CITY OF ALBUQUERQUE

RE: **Lot 39 Block 6 Volcano Cliffs Unit 22 SAD 228**
6504 Papagayo Rd. NW
Grading and Drainage Plan
Engineers Stamp Date 11/23/19 (D10D003O3)
Pad Certification Date 3/19/20

DRAINAGE AND TRANSPORTATION INFORMATION SHEET (REV 6/2018)

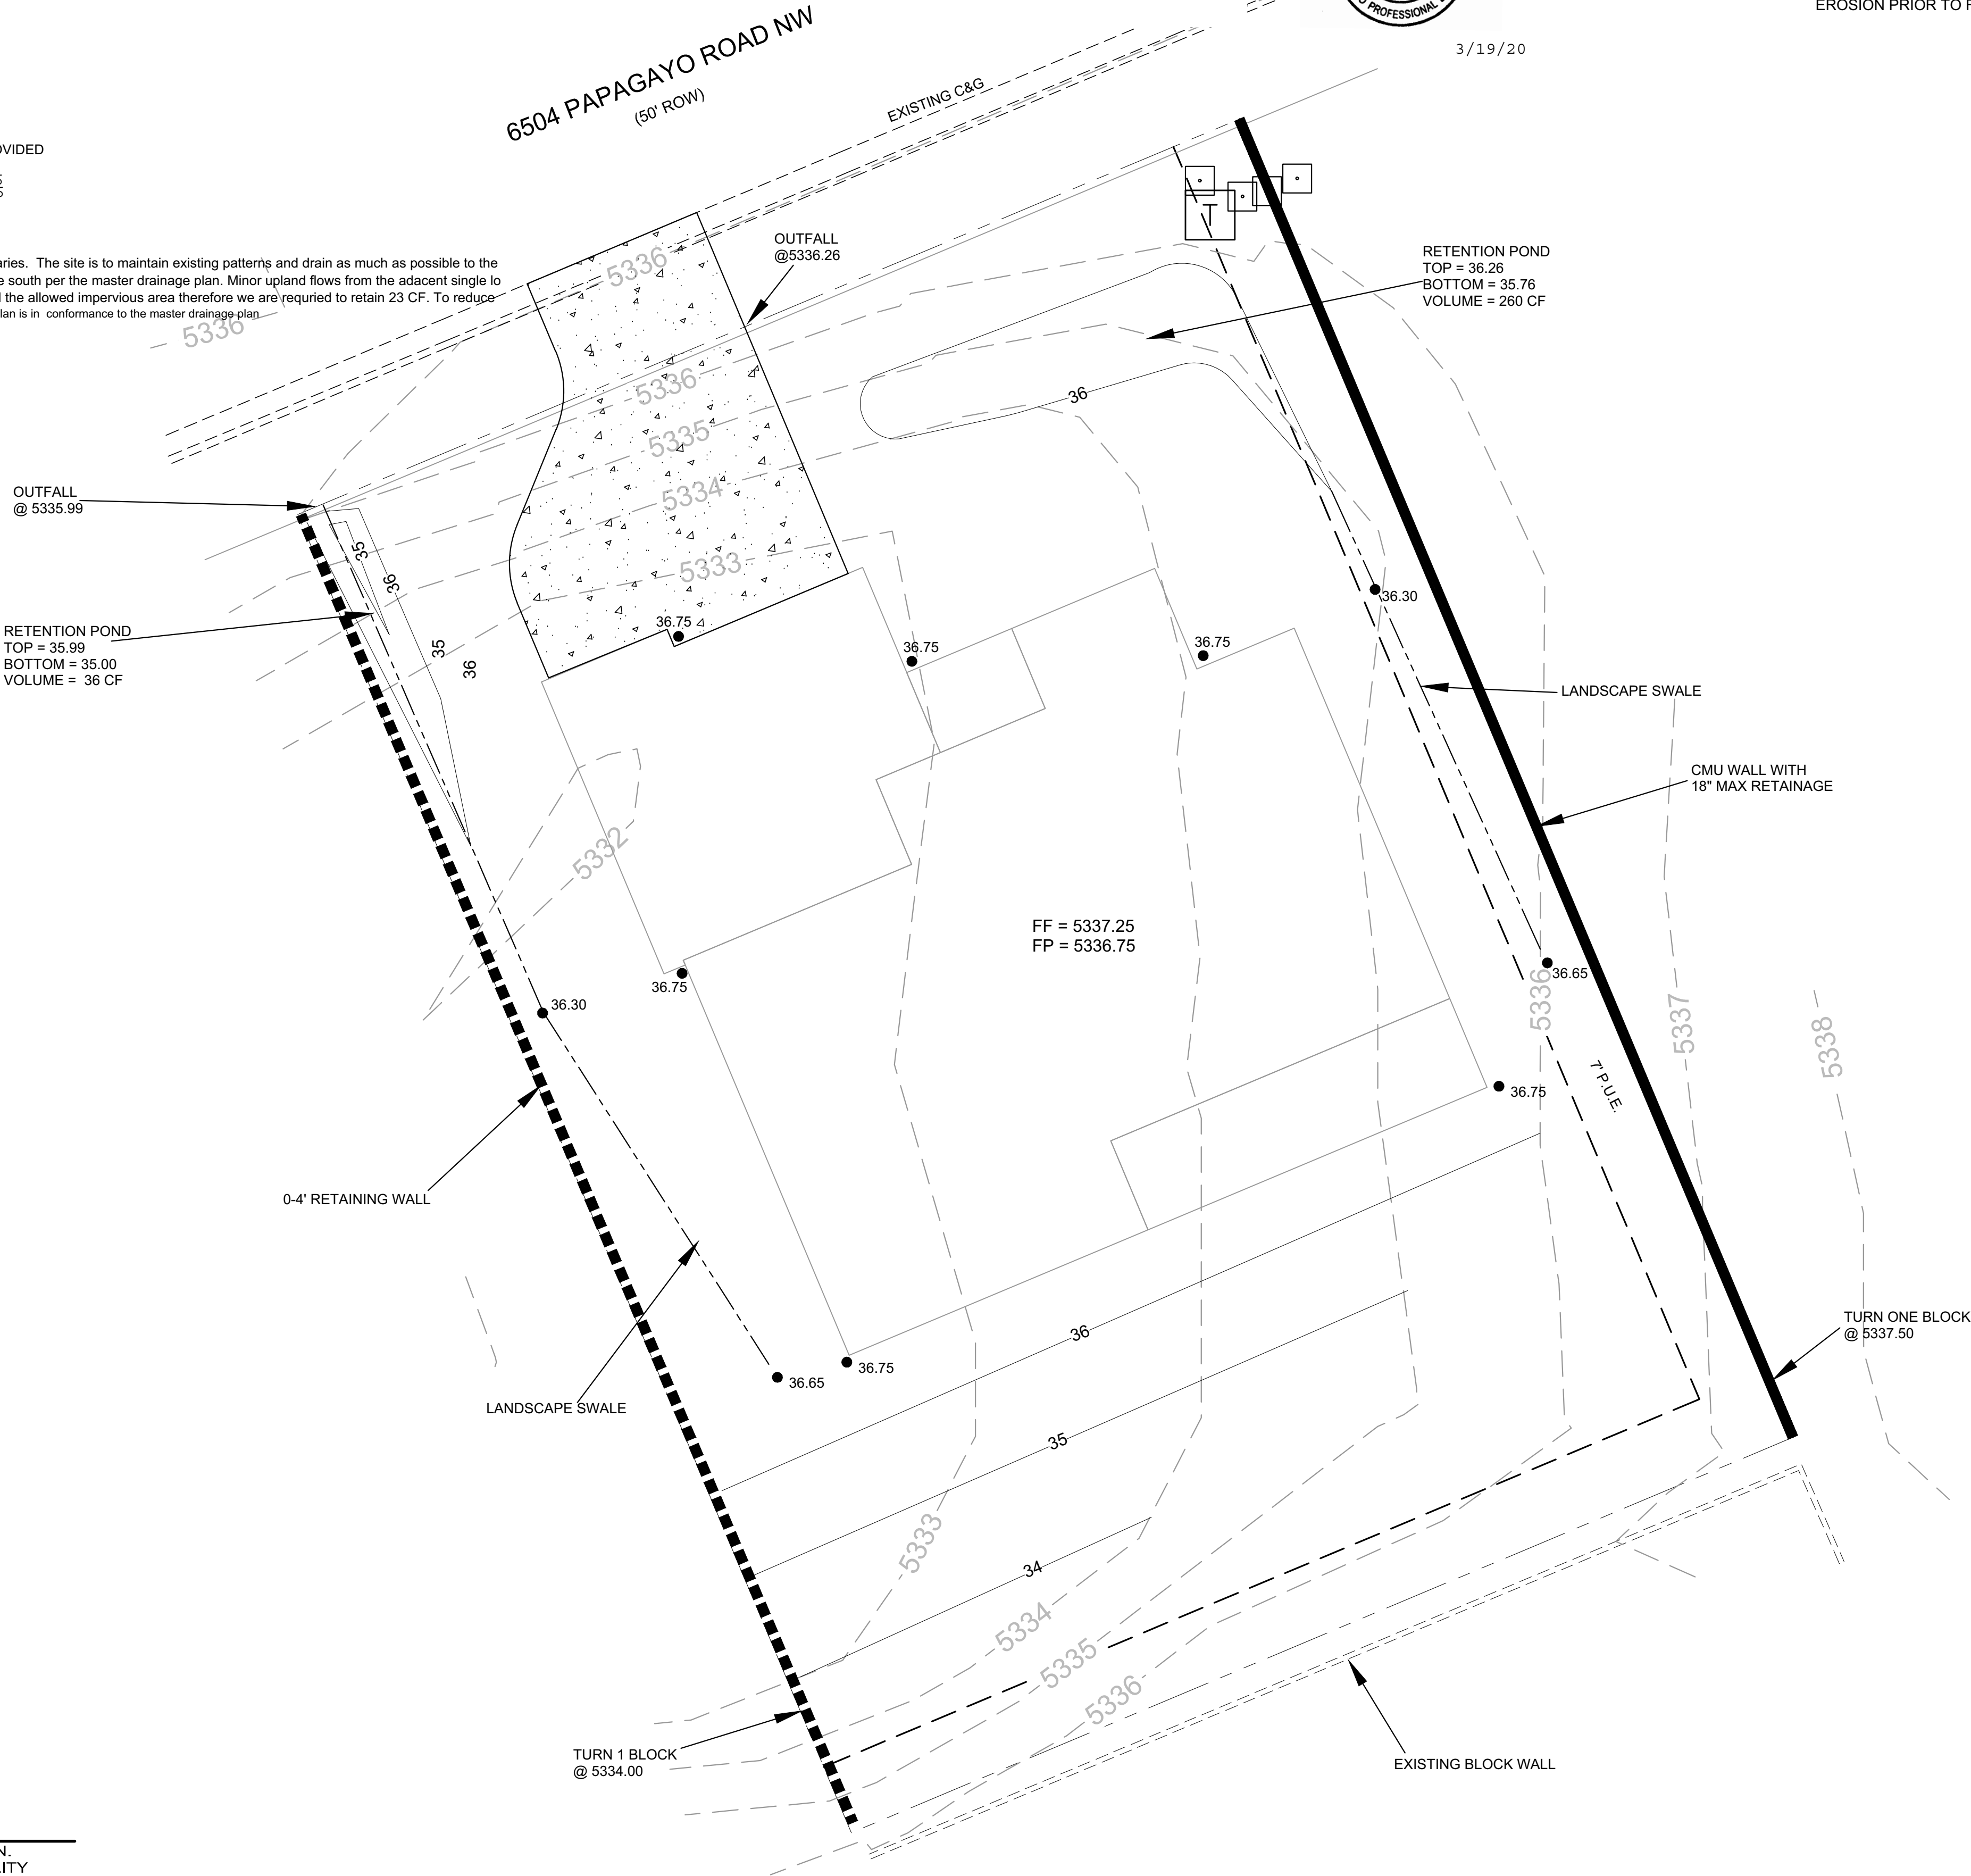
Based upon the information provided in your submittal received 3/20/20, this plan is approved for Building Permit.

Reiterate to the Owner/Contractor that a separate permit for a garden/retaining wall must be obtained, with the approved G&D plan dated 11/23/19 and Pad Certification Date 3/19/20.

Prior to Certificate of Occupancy release, Engineer Certification per the DPM checklist of this plan will be required.
